LOFT Preliminary Requirements Review (PRR) Technical and Programmatic Report

Prepared by LOFT PRR Panel
Reference ESA-LOFT-RP-0006
Issue 1
Revision 3
Date of Issue 10/12/2013
Status
Document Type RP
Distribution

Figure 2: LOFT ESA requirement tree

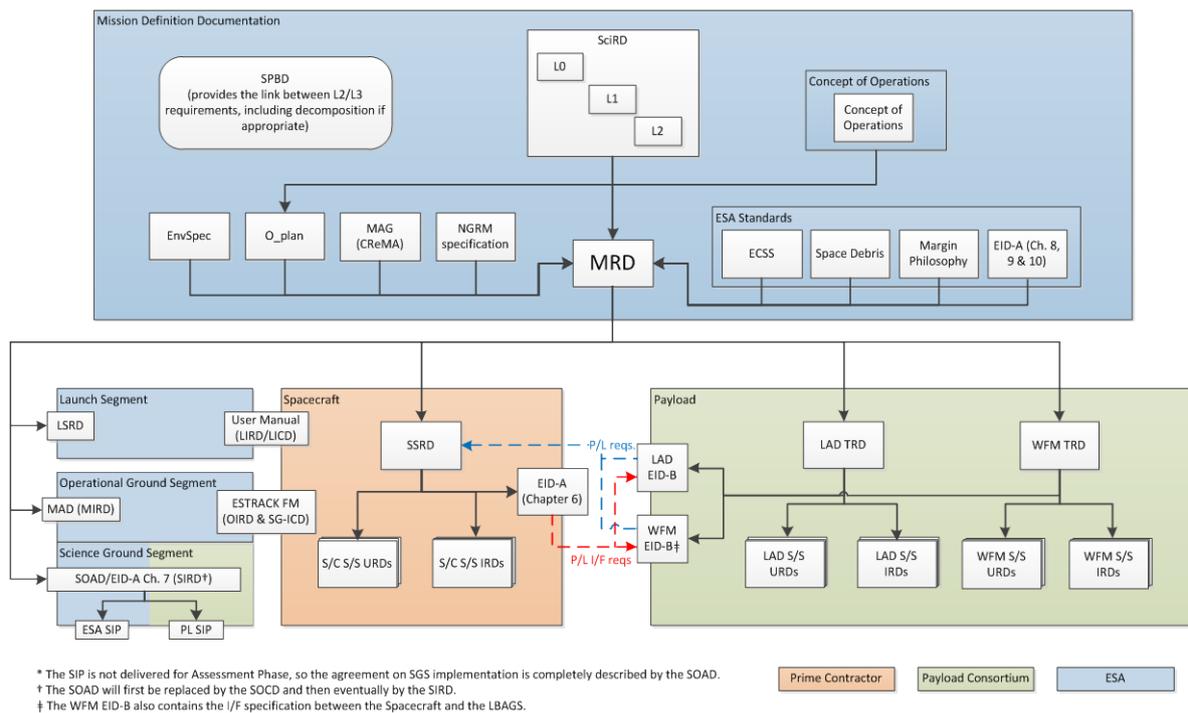
The specification tree has been properly structured (see Figure 2) and is adequate for Phase A. It is based on the following key documents:

with a clear traceability and sound first iteration of the requirement breakdown, and unambiguous allocation of requirements to the different mission elements.

For the next project phase it is recommended to produce a System Requirement Document (SRD) & Payload Requirements Document (PRD) to elaborate requirements on the Spacecraft and payload (these are currently held as MRD chapters.)

Figure 5: ASTRIUM SC design (also shown stowed in fairing)

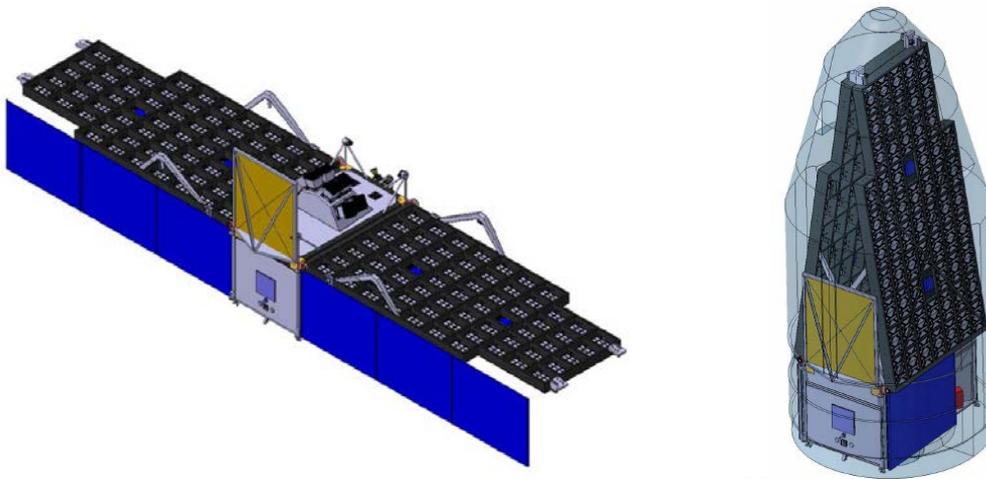
Launcher compatibility: although the proposed design is currently compatible with a Soyuz launch, margins in terms of volume inside the fairing, adapter, and performance are limited. The proposed design fills almost completely the volume envelope inside the Soyuz fairing (see Figure 5); any future growth in payload or platform dimensions may result in the need to remove some rows or columns of LAD modules to fit within the fairing (estimated ~11% loss of effective area.) Furthermore, due to the large spacecraft mass and the relatively high position of the CoG, the margin in terms of static moment for the PAS 1666 launch adapter is minimal (~0.6%). Should the static moment further increase in the future, then a reinforcement of the clamp-band and a delta-qualification of the launcher adapter might become necessary. In terms of launcher performance, the mass of the current design (including all margins) is 276 kg lower than the expected launcher performance (also considering a 5% launcher performance margin) to the reference orbit.

Figure 7: TAS and ASTRIUM SC orbital average (not taking into account $\sim\pm 5$ deg C variation along the orbit) predicted LAD equivalent temperature as a function of Sun aspect Angle

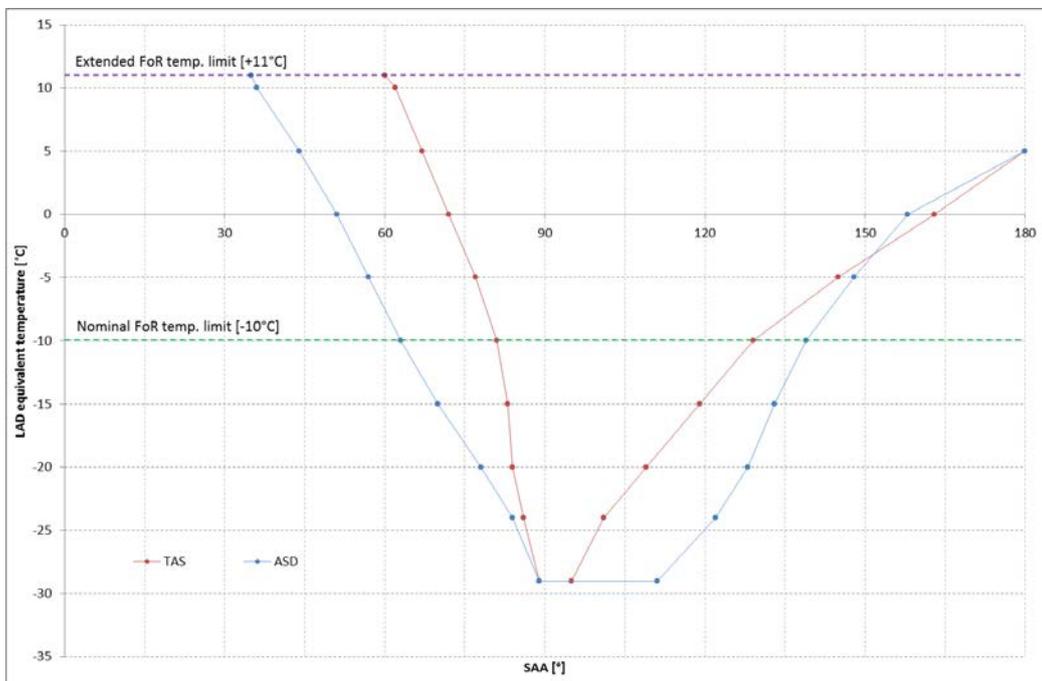
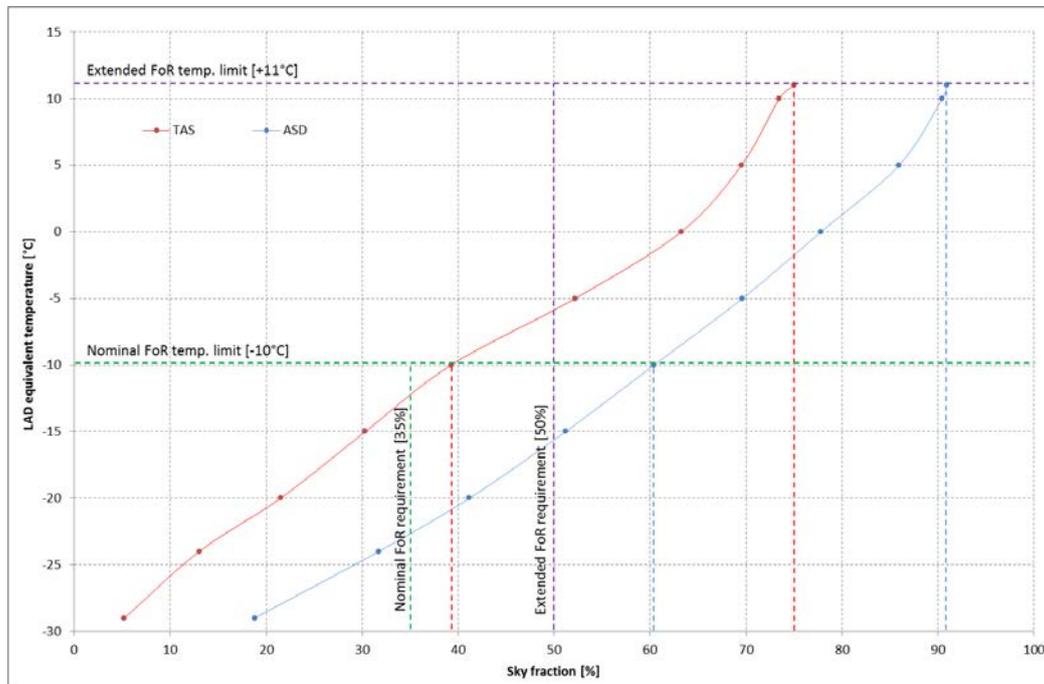
In the cold cases, the LAD absolute temperatures are close to the minimum allowed temperatures in some operational (SAA of 90°) and non-operational (panels stowed, safe mode) scenarios. **Therefore the recommendation of the panel is to baseline LAD Module heaters in order to limit the impact of this uncertainty for future phases** (this solution has already been adopted by TAS-I.)

Figure 11: Magnified photographs of the small-size, 100 μm pore capillary plate produced by Hamamatsu (Japan) to test the feasibility of the LOFT specifications

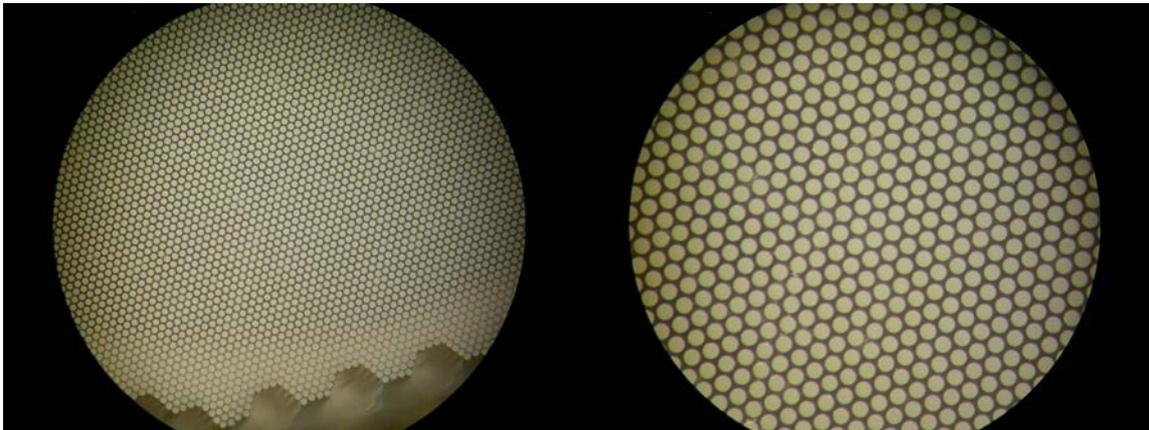
The PRR baseline for the LAD Collimator has been a square pore collimator. Standard technology for Micro Channel Plates (for e.g. night vision applications) are round pores that are easier and significantly cheaper to manufacture than square pores, with the drawback that a slightly worse pore alignment performance is expected for round pores. However a round pore demonstrator with 1.8arcmin pore alignment (requirement is 1arcmin) has already been manufactured by Hamamatsu (Japan, see Figure 12), but with 60% Open Area Ratio (OAR) only. The underperformance in pore alignment corresponds to a small reduction of Effective Area that can be compensated with the surplus LAD Modules that can be accommodated on the SC (124/125 instead of required 121). Increasing the OAR to 70% is not considered technically challenging but still remains to be demonstrated. *The PRR therefore recommends to further investigate the option of using round pore MPCs for the LAD instrument. Based the expected cost, manufacturing duration and risk reduction, the PRR recommends round pore collimators as the new baseline for the LAD instrument.* Talks with the European MPC supplier have already been started and demonstrating round pore MPCs for the LAD instrument within 2014 appears feasible.

There is a discussion currently underway concerning the possible replacement of square-pore with round-pore collimators. Round pores are the standard technology for commercial/night vision applications and provide similar performance, are easier and less risky to manufacture, and are less expensive than round pores. Consequently an additional TDA with PHOTONIS is envisaged to start in 2014 after mission selection to demonstrate technical feasibility and performance early 2015. The main concern that needs to be addressed by this TDA is that the round pore technology for an OAR of 70% does not provide the specified pore alignment performance, for a lower OAR of 60% pore alignment of 1.8arcmin instead of the specified 1arcmin have been demonstrated by HAMAMATSU.
